Well Name: SEINFELD FEDERAL UNIT GIPPLE	Well Location: T24S / R35E / SEC 33 / SESE /	County or Parish/State:
Well Number: 224H	Type of Well: OIL WELL	Allottee or Tribe Name:
Lease Number: NMNM138893	Unit or CA Name:	Unit or CA Number: NMNM141169X
US Well Number: 3002551155	Well Status: Approved Application for Permit to Drill	Operator: TAP ROCK OPERATING LLC

Notice of Intent

Type of Submission: Notice of Intent	Type of Action: APD Change
Date Sundry Submitted: 04/12/2023	Time Sundry Submitted: 11:20
Date proposed operation will begin: 04/12/2023

Drilling Operations Plan
Seinfeld Federal Unit Gipple Com #224H
Tap Rock Operating, LLC
SHL 175' FSL & 770' FEL, Sec. 33
BHL 5' FNL & 660' FEL, Sec. 28
T. 24S., R. 35E Lea County, NM

WELL LOCATION AND ACREAGE DEDICATION PLAT

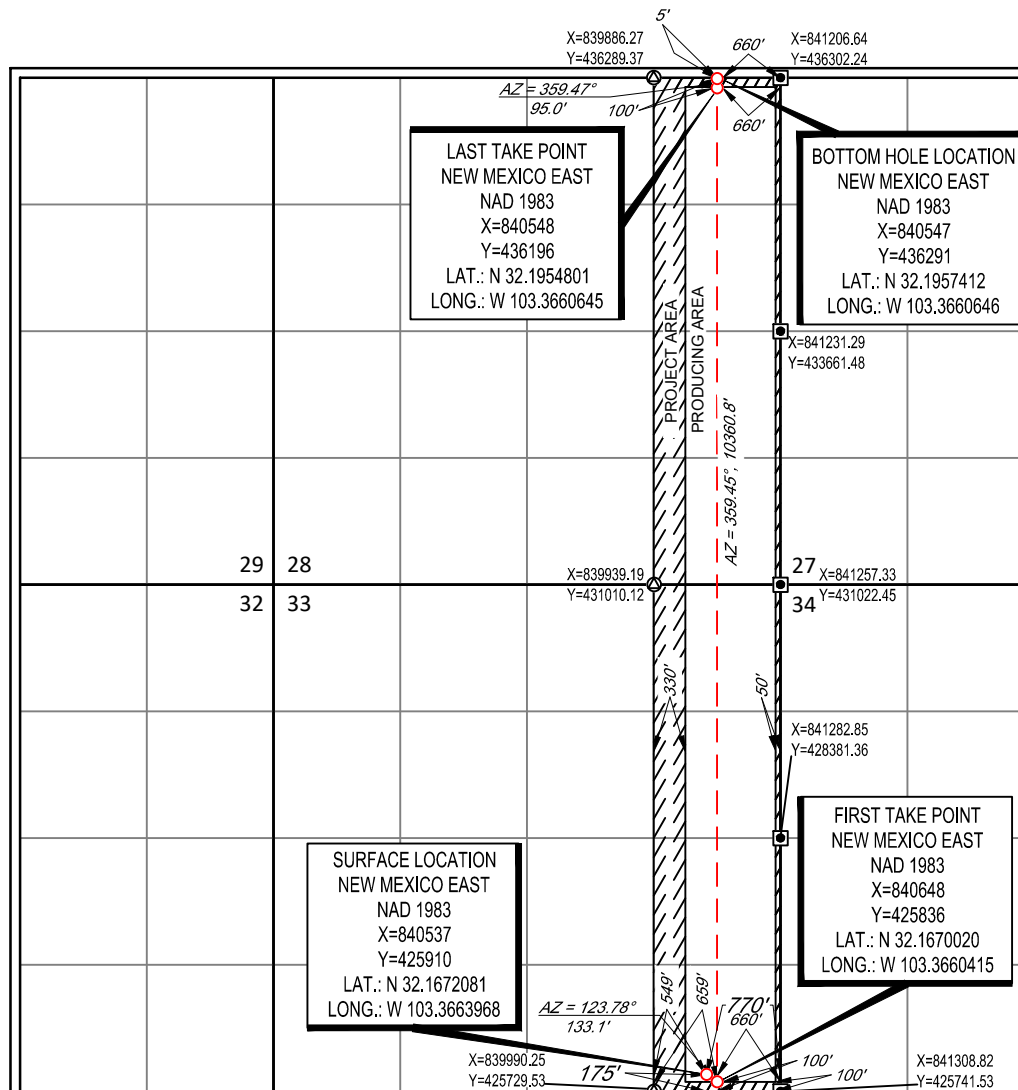
Procedure Description: For the referenced well, Tap Rock requests: 1. To change the referenced well name from Gipple Fed Com 224H to: Seinfeld Federal Unit Gipple 224H. See attached updated C-102. 2. To change modify OH size and casing/cement design. See attached casing, cement, and mud tables.
